ACS1999-PW-PLN-0021  
(File: OLV1998/004)

Department of Urban Planning and Public  
Works

### **Subdivision - 1555 -1565 Johnston Road**

### CITY CONDITIONS TO BE ADDED TO REGIONAL SUBDIVISION APPROVAL

DRAFT PLAN OF SUBDIVISION TO  
PART OF LOT 3  
CONCESSION 4 (Rideau Front)  
FORMERLY FORMERLY  
NOW IN THE CITY OF OTTAWA  
SCALE 1:5000

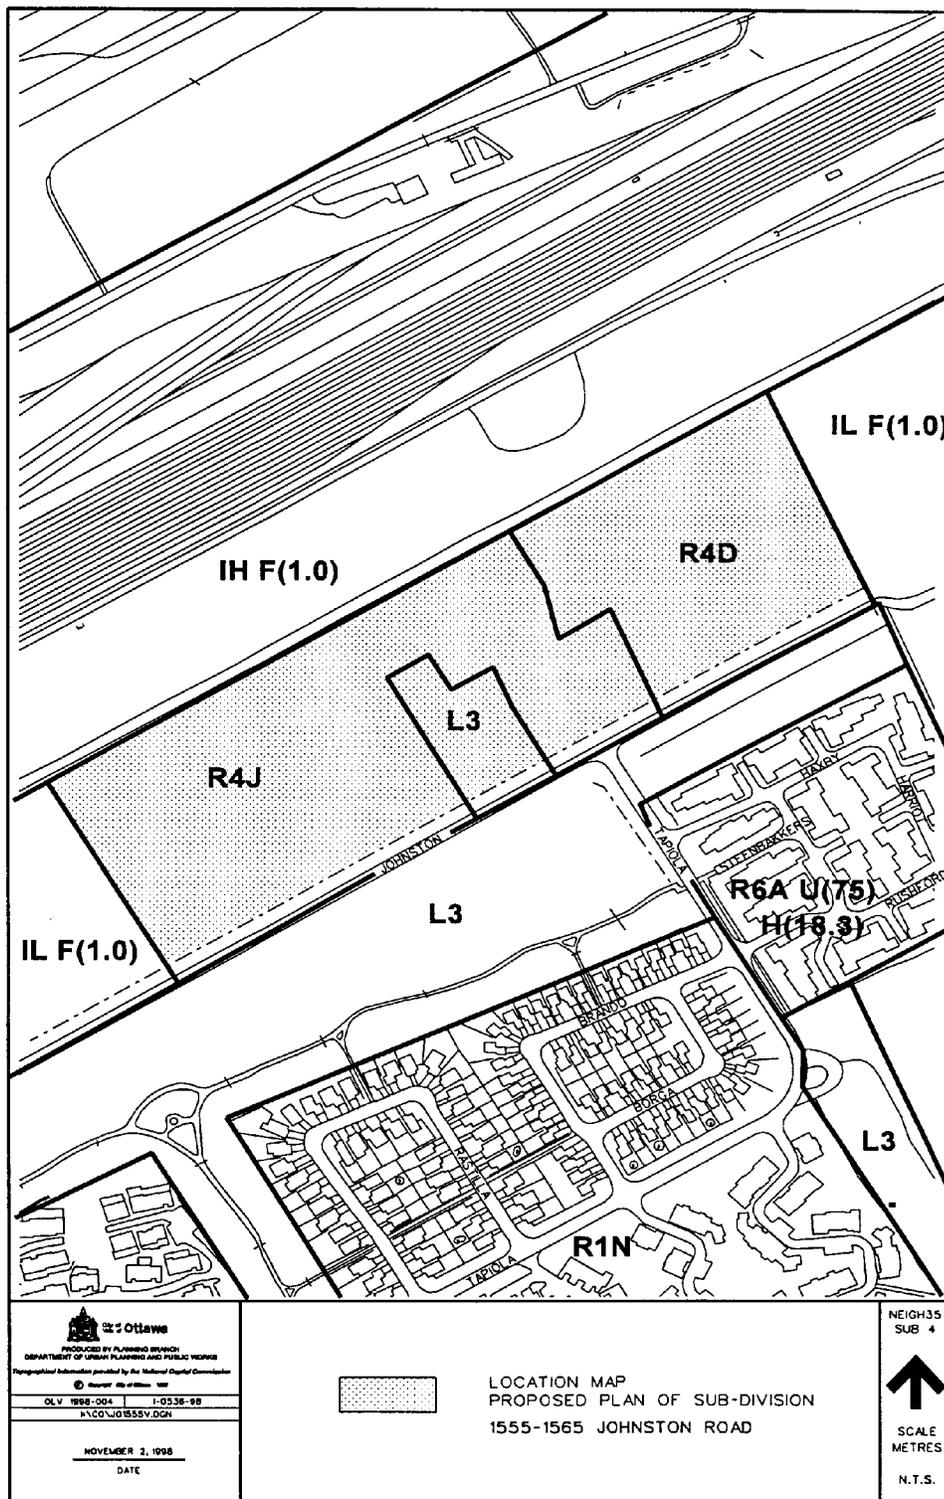
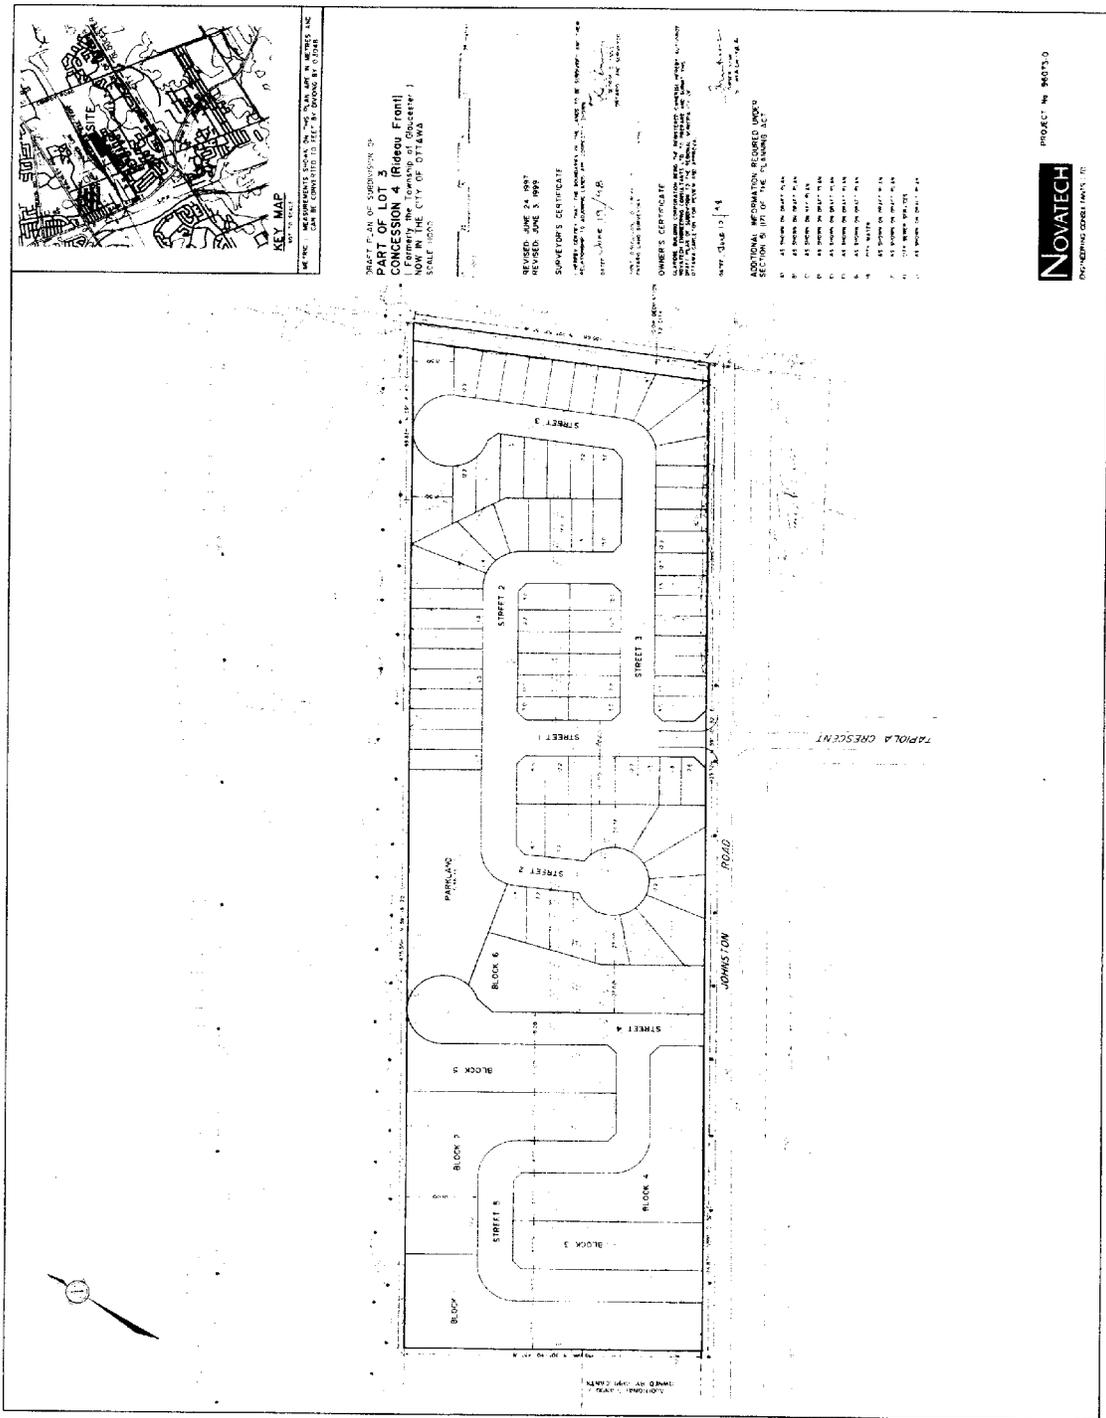
1. Consideration of the proposed subdivision should be deferred until the outcome of the appeal of the rezoning amendment before the Ontario Municipal Board.

2. The developer must incorporate the one lot setback previously imposed by City Council, into the proposed plan of subdivision.
3. I disapprove of planning staff's position that the developer does not have to comply with providing the one lot setback, because the setback is zoned residential. This smacks of favouritism to the developer, is inappropriate and discourages the general public from participating in the planning process.

4. Why not have a one-lot depth setback that is a conservation easement.
5. I am pleased that the draft plan of subdivision appears to incorporate the provisions of an agreement worked out with a member of the community. A 10-metres buffer on the north might make living there more tolerable, but a 10-metre setback along the east is not an adequate buffer from the swamp.

6. There should be no cul-de-sacs. There could be hazardous materials on cars in the yard. There could be leaks and explosions. The site has to be planned for easy evacuation. Furthermore, the Region's Official Plan states that cul-de-sacs should be minimized.

7. The proposed streets do not provide adequate on-street parking.
8. The park as proposed, will only serve half the households in the community. The park should be connected to the greenway system to the south by some sort of path.
9. This subdivision should be laid out so as to protect the existing watercourses on the site. Preserving these creeks would make this a much more inviting place to live.
10. The circulation sent to Community Groups did not contain a large map showing the plan of subdivision.
11. I am not aware of any conditions of subdivision being circulated for public comment. We have not had the opportunity to comment on any conditions that are being imposed on by the developer.
12. There should be a sidewalk along the entire south end of the property and connect with the existing pathway system in the Greenboro Area.

2. The subdivision plan does not allow internal road, or path access from the west end of the site to the parkland. Could a road link, or pedestrian pathway be incorporated in the plan?

1. The developer has revised his application for development of the subject property. This revised application is to replace the previous proposal, which has been appealed to the Ontario Municipal Board. Revisions to a proposal are not uncommon, especially when it attempts to resolve outstanding issues. This revised amendment was fostered by negotiations with an appellant to the previous proposal. Nevertheless, it is unlikely the Ontario Municipal Board would entertain the possibility of having a hearing on the previous proposal, given the subject revisions.

2. During City Council's discussions for the previous development proposal, it was determined that staff would report back to Council on the recommended setback from the GTNA. It was also determined that the conclusions of the NOSS would specify the setback recommendations. The NOSS requires a buffer from the GTNA of 15 metres. The Department is recommending that 10 metres of the subject site along the eastern boundary of property be deeded to the City. The remaining five metres is outside the boundary of this site and has already been deeded to the City. Given the evidence from the NOSS, imposition of a larger setback does not seem reasonable and would be difficult to substantiate at the OMB. The setback necessitated by the NOSS will be zoned Environmentally Sensitive Area.

3. Recommendations to Council are made on sound planning principles, not on favouritism. By recommending a 10 metre setback from the subject property based on the findings of the NOSS, the Department is following the direction of Council.

4. As mentioned, the requirement of a one-lot depth (approximately 30 metres) from the GTNA is not required to maintain the integrity of this area. As part of the complementary rezoning submission, the Department is recommending that this land be rezoned to Environmentally Sensitive Area. As part of this submission, there is a recommendation requiring that the applicant deed this area to the City. Previous experience with conservation easements have raised concerns about this method's ability to actually protect that feature.

5. The requirement for a 10-metre setback along the northern boundary of the property has been accommodated within the Regional draft approval of the Plan of Subdivision. The developer has agreed to abide by this condition of draft approval. As mentioned above, the setback from the GTNA is 15 metres, 10 of which will be provided from the subject site.

6. Proposed cul-de-sacs are not expected to create any access and egress hazards for the community.
7. It is the Department's position that there is adequate parking on-street to meet the needs of the development.

8. The park for this proposed community has been relocated to a more central position. As part of the special conditions for the subdivision, the developer will be required to construct sidewalks which link to the existing pathway system.

9. The storm water management system proposed will preserve the existing watercourses on site. The ditch to the north will be relocated and the ditch to the east will be deeded to the City. The effect will be to maintain the current level of surface water flow to the GTNA.
